SUBSURFACE SEWAGE TREATMENT SYSTEM (SSTS) COMPLIANCE REPORT

Date: November 13, 2019

Inspection Address: 9321 107th St N, Grant, MN 55082

Subsurface Sewage Treatment System Owner/Property Information

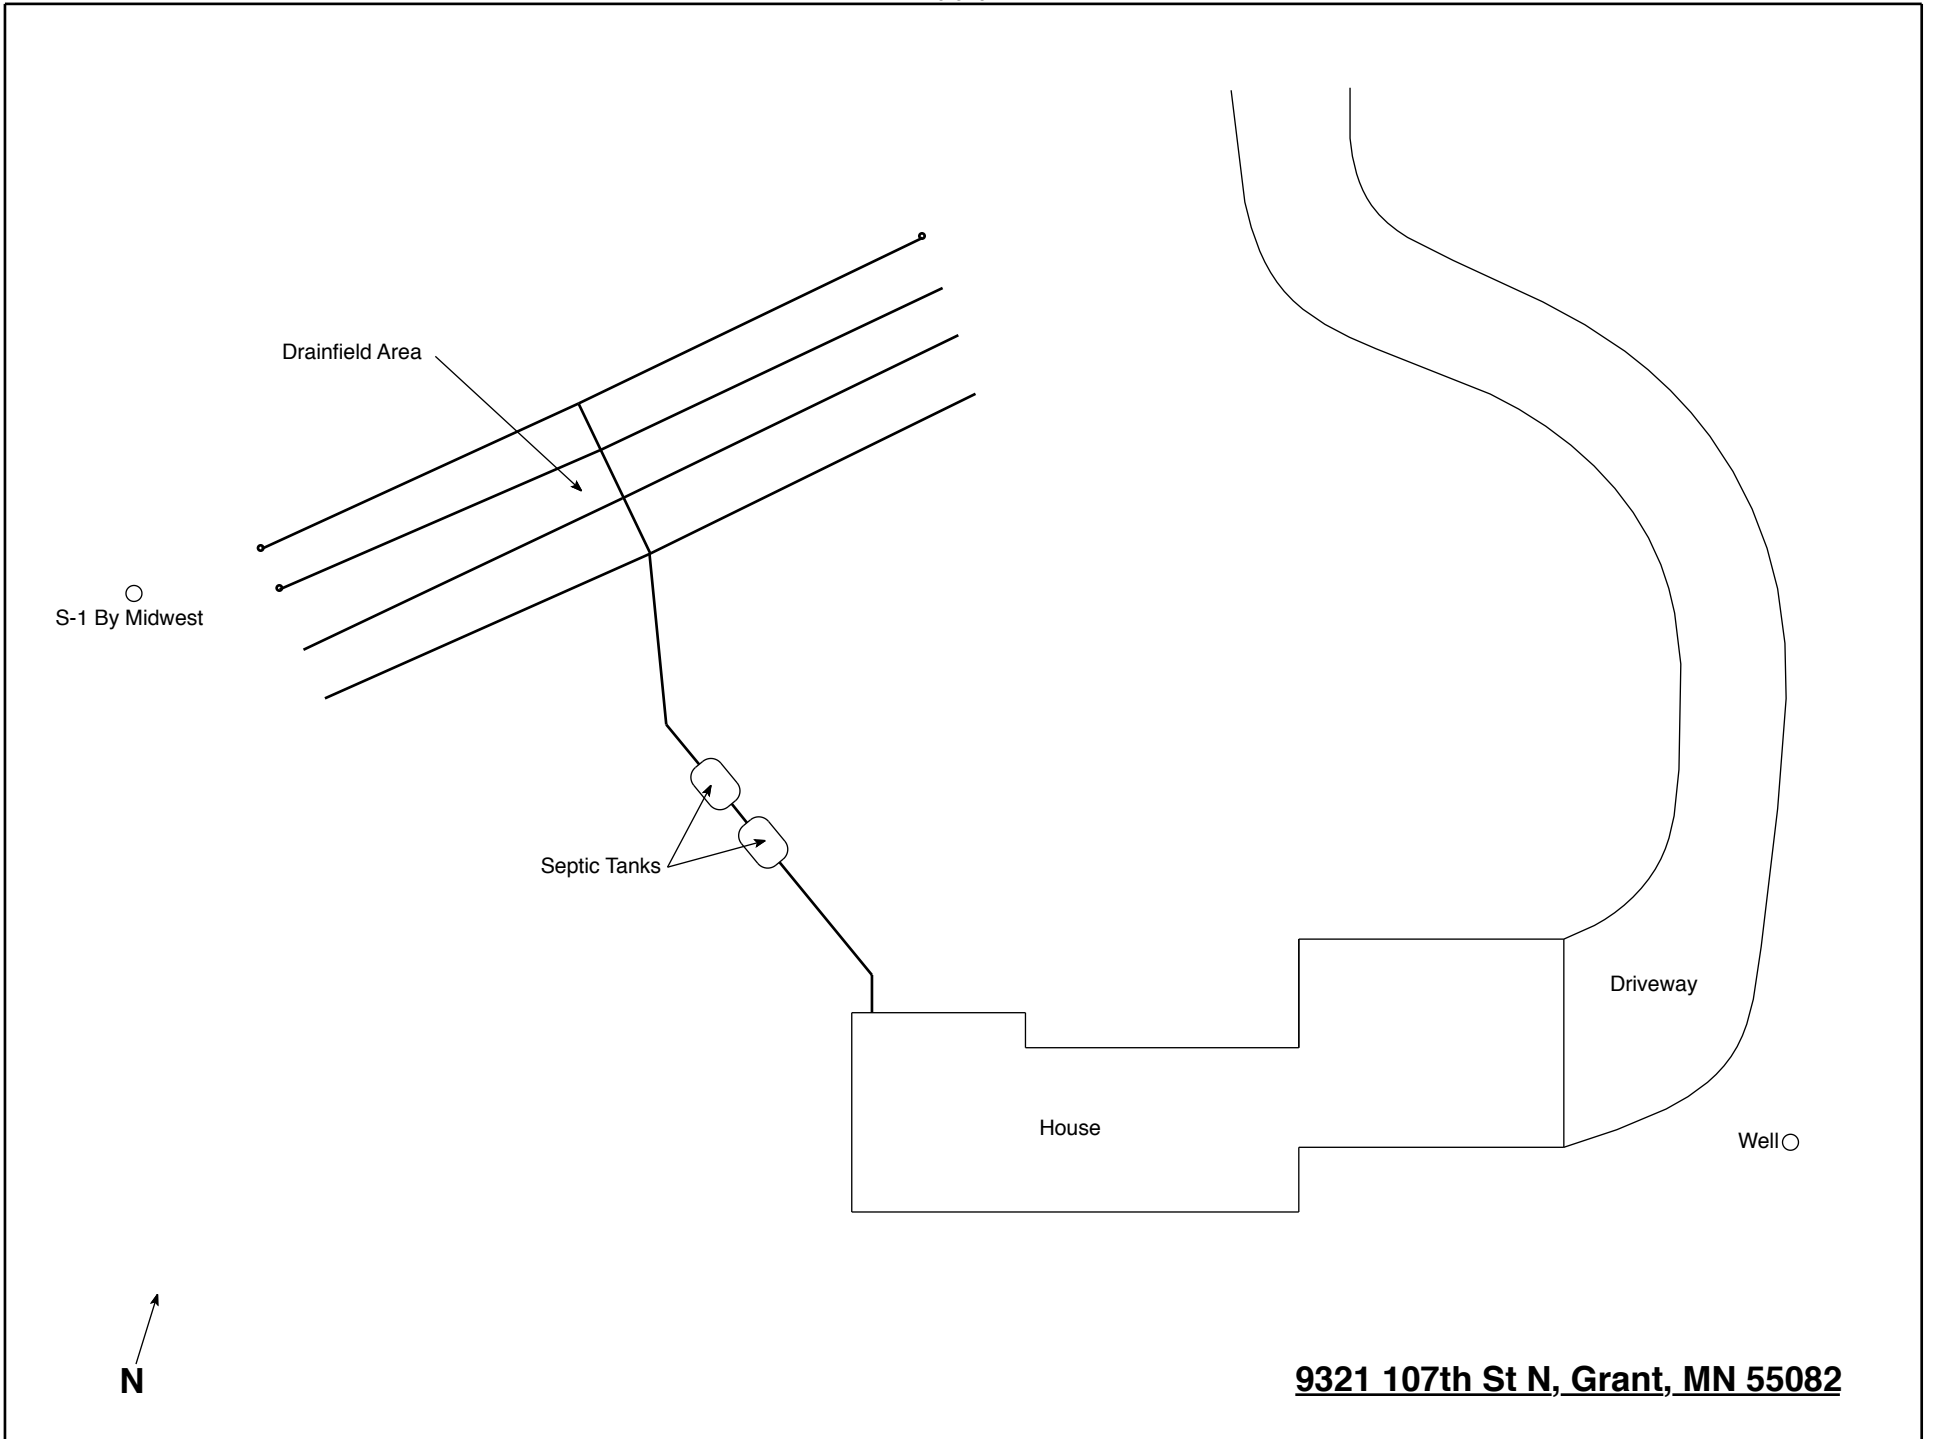
Are the tank maintenance covers accessible? <input checked="" type="checkbox"/> Yes <input type="checkbox"/> No *If no, proper maintenance must be performed through the maintenance holes. Maintenance hole covers should be made accessible to the ground surface to facilitate access and proper maintenance of the system.			
Year house built: 1993	Year septic installed: 1993	Tank size (gals.): 2-1565	
How long has seller owned the property? 1993		Number of residents in home? 2-5	
Number of bedrooms? 4	Are all floors drained by gravity? Y		
Garbage disposal? Y		Whirlpool bath? Y	
More than one system (laundry, etc.)? N			
Does this property have any footing drain tiles connected to the septic system? N			
Are any buildings on this property such as garages or out-buildings connected to this system? N			
Are there any additional systems on this property serving other buildings? N			
Location of septic system on lot? Northwest Side

Location of water well on lot? East Side		Is the well a deep well? Y	
Have you ever experienced any problems with the system such as: tree roots, sewage back-ups, surfacing of sewage onto the ground, septic tank overflowing, etc.; or have any repairs been made to the system? N If yes, explain:			
When was the system last pumped? 2019		Name of pumper: Smilie's Sewer Service	
How often pumped in previous years? Every 3		Is system on a monitoring plan? N	
Have you received notices from any government agency concerning this system? N			
Is your property located in a shoreland management area? N			
Do you have any additional information that should be given to the new owner? N
